Access Compliance Report

Public Rights-of-Way

(Curb Ramps)

Intersection ID: 27333	Main Street: BALLANTYNE_MEDICAL_PL	Cross Street: N/A	Location: SE
ADA ID: 83F50F913FEB	Ramp Type: Perp	Initial Pass/Fail: Fail	Overall Compliance: No
Codes/Mitigation Info/Possible Solution		Field Measurements/Component Compliance	
Severity Score: 12.5

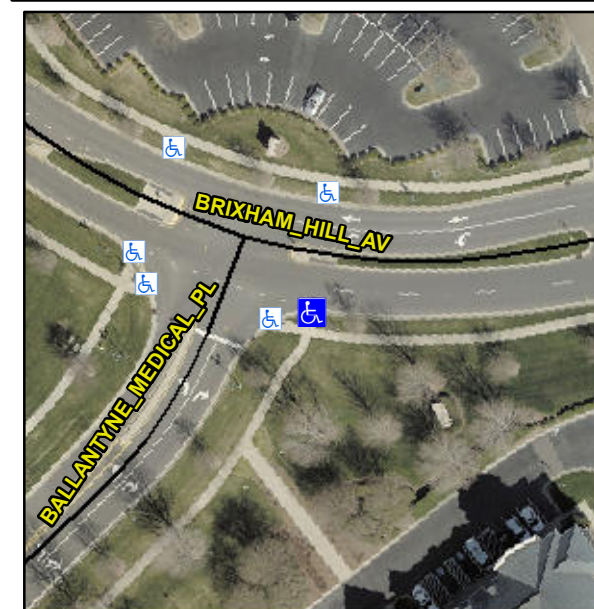
Not Found, R304.2.2

Remove & Replace Entire Ramp.
